New Recommended Circuit for R5460

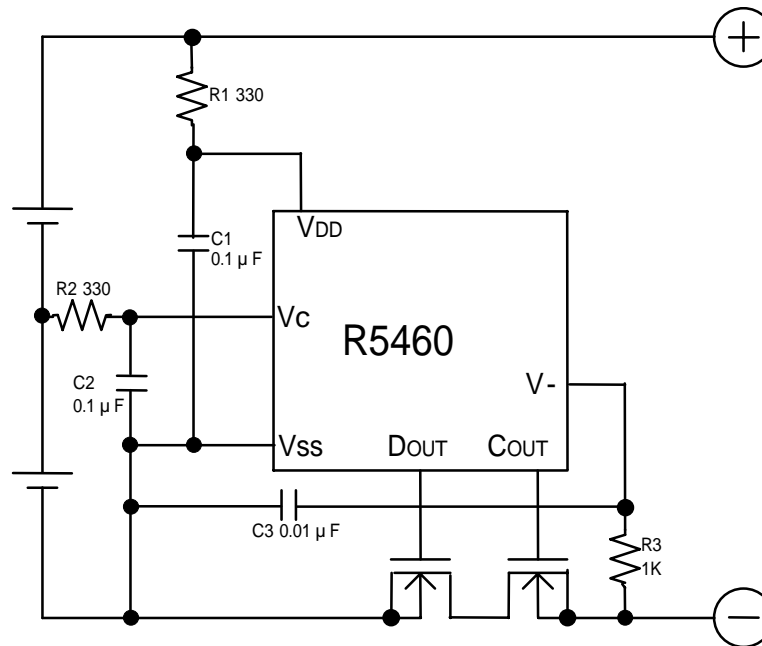
R1, R2, C1 and C2 stabilize a supply voltage to the R5460xxxxxx. A recommended R1, R2 value is less than 1K . A larger value of R1 and R2 makes the detection voltage shift higher because of some conduction current in the R5460xxxxxx. To stabilize the operation, the value of C1 and C2 should be equal or more than 0.01 μ F.

R1 and R3 can operate also as parts for current limit circuit against reverse charge or applying a charger with excess charging voltage beyond the absolute maximum rating of the R5460xxxxxx, the battery pack. Small value of R1 and R3 may cause over-power consumption rating of power dissipation of the R5460xxxxxx. Thus, the total value of 'R1+R3' should be equal or more than 1K .

If R3 value is set too large, after detecting over-discharge, release operation by connecting a charger may be impossible, our recommendation value as R3 is 3K or less.

To stabilize the operation of the IC, use 0.01 μ F or more capacitor as C3.
